Access Compliance Report

Public Rights-of-Way

(Curb Ramps)

Intersection ID: 12428	Main Street: E_7TH_ST	Cross Street: N_CALDWELL_ST	Location: N
ADA ID: 1CA4D2B6103D	Ramp Type: PerpDiag	Initial Pass/Fail: Fail	Overall Compliance: No
			Severity Score: 21.25

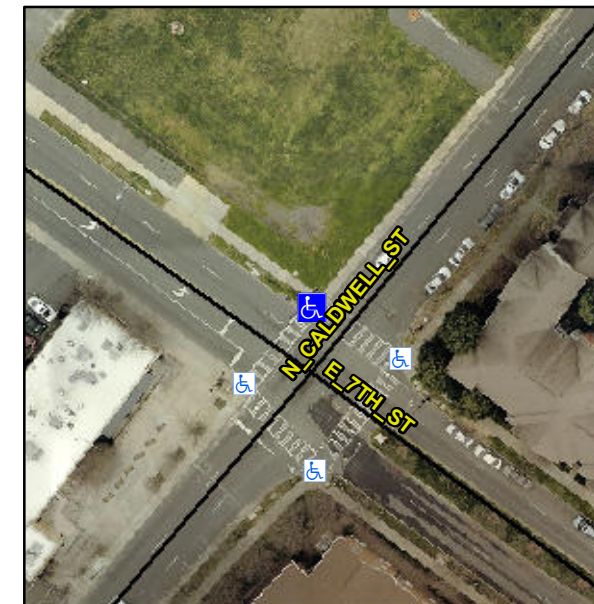
R304.5.1, R304.5.3

Compliance	Description	Data	Compliance	Description	Data
N/A	Ramp Length (in)	62.0	Yes	Ramp Slope (%)	5.1
No	Ramp Width (in)	47.0	No	Ramp XSlope (%)	5.6
N/A	Flare Type LT	N/A	N/A	Flare Type RT	N/A
N/A	Flare Slope LT (%)	N/A	N/A	Flare Slope RT (%)	N/A
N/A	Flare Traversable LT?	N/A	N/A	Flare Traversable RT?	N/A
N/A	Landing Length (in)	N/A	N/A	DWS Provided?	N/A
N/A	Landing Width (in)	N/A	N/A	DWS Contrast?	N/A
N/A	Landing Slope (%)	N/A	N/A	DWS Length (in)	N/A
N/A	Landing X Slope (%)	N/A	N/A	DWS Full Width?	N/A
N/A	Landing Curb? (Y/N)	N/A	N/A	DWS Offset (in)	N/A
N/A	Shared Landing?	N/A			
N/A	Gutter Ponding?	N/A	N/A	Gutter Slope (%)	N/A
N/A	Gutter Lip Ht (in)	N/A	N/A	Gutter X Slope (%)	N/A
N/A	Painted X Walk1?	Yes	N/A	Painted X Walk2?	Yes
	X Walk 1 Direction	To SW		X Walk 2 Direction	To SE
N/A	X Walk 1 Width (in)	80.0	N/A	X Walk 2 Width (in)	130.0
	X Walk 1 Slope (%)	0.0		X Walk 2 Slope (%)	0.1
	X Walk 1 X Slope (%)	1.8		X Walk 2 X Slope (%)	2.3

Remove & Replace Curb Ramp With Two New Directional Ramps or Equivalent.
